SEWAGE DISPOSAL SYSTEM

MARYLAND STATE DEPARTMENT OF HEALTH*

SUBDIVISION Bethany Village ROAD 9999 Route 99 LOT 3, Section 1

GRADING STUDY

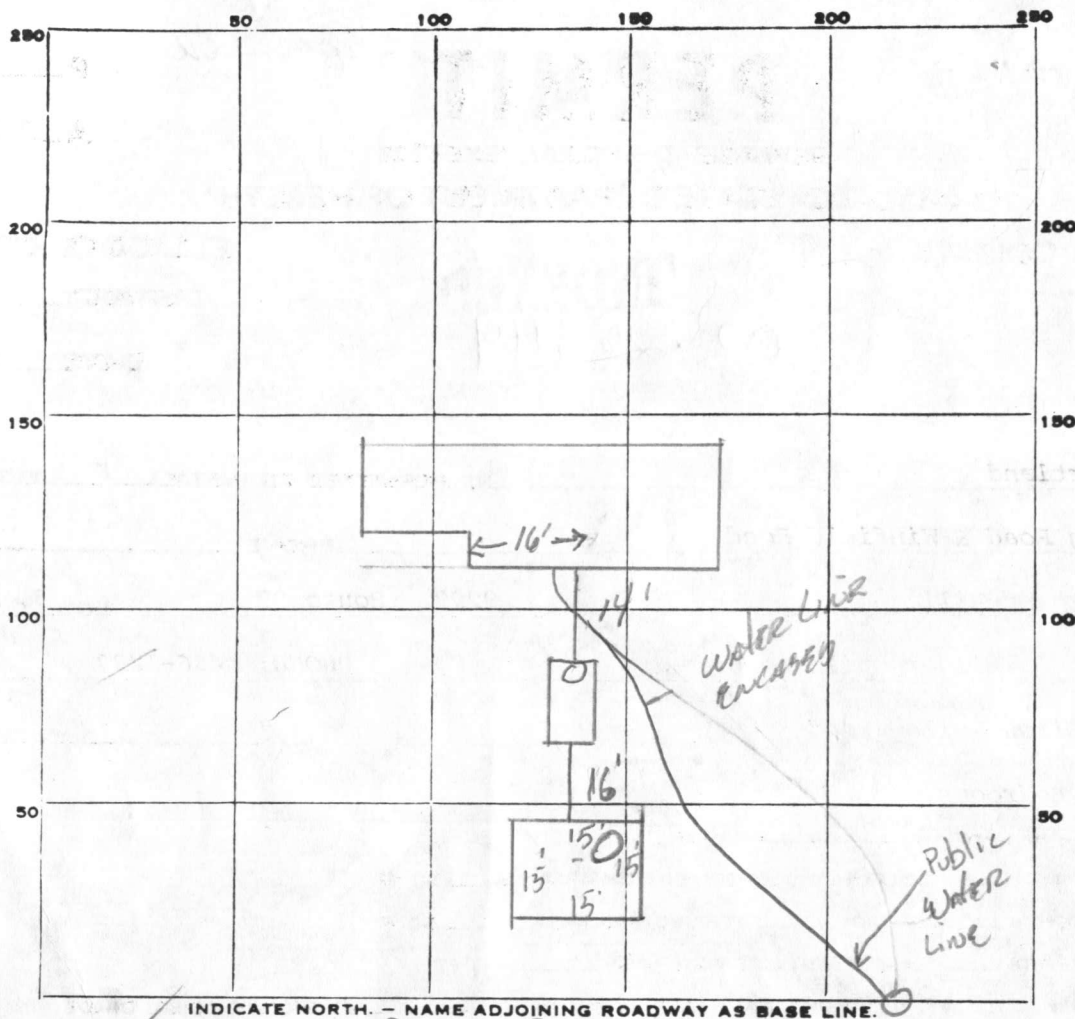
REMARKS 9-23-80 OK To Cover Dry Well, Water Line
Running through Sewage Easement, Must be increased or moved,
To much fall in last 10' of pipe to Tank, can be no greater than
1/4" per foot. SR 9-23-80 Talked to contractor after inspection about
connections needed will increase water line & lower house sewer SR
9-23-80 Water line increased from house through sewage easement, House sewer
connected. SR

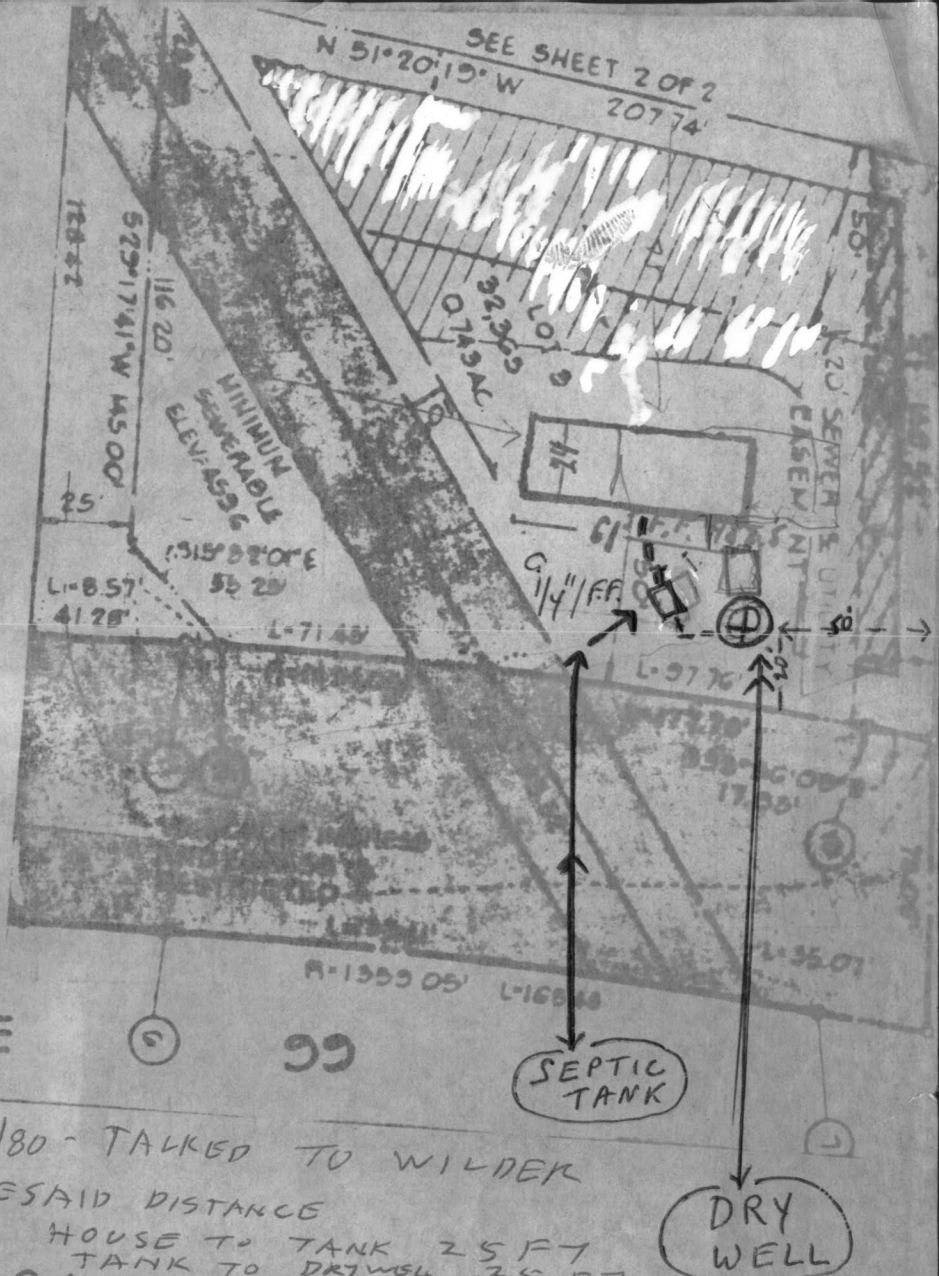
4/8/80 - TALKED TO WILDER
HE SAID DISTANCE
HOUSE TO TANK 25 FT
TANK TO DRYWELL 25 FT

REVISED PLANS
OK AFTER
MAKING
CORRECTIONS
OVER PHONE
